MINUTES**DETROIT HISTORIC DISTRICT COMMISSION REGULAR MEETING**

October 8, 2025

DISTRIBUTED TO COMMISSION
RE 2233 PARK,
10/8/25

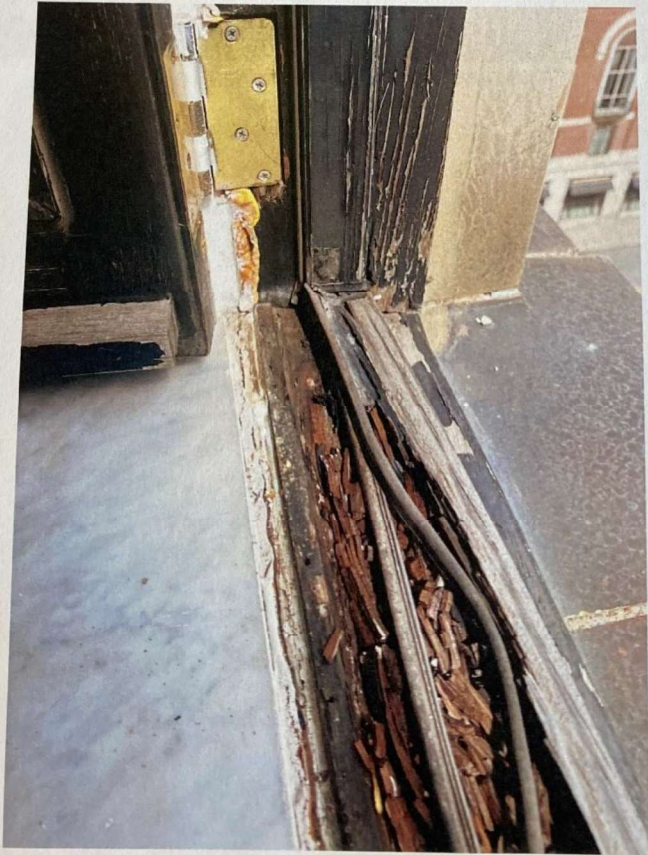
Mr. Flum stated that the windows really are beyond repair. They have proposed a different window replacement, but this time are proposing a window with a vertical grill in the lower sash to better replicate what is there, and the brick mold with this window is almost identical to the historic.

Commissioners and applicants discussed operation. Could the transom above open (awning or hopper) and the window with the muntin or meeting rail be fixed in place? Director Landsberg offered clarification that with replacements, the visual matching of the new window to the historic is more important than the operation, by National Park Service guidance.

- the proposed vertical strip on the lower sash of the cottage window will be six inches wide rather than three inches wide.

[The edge profile of that muntin will be ogee as proposed in the application.]
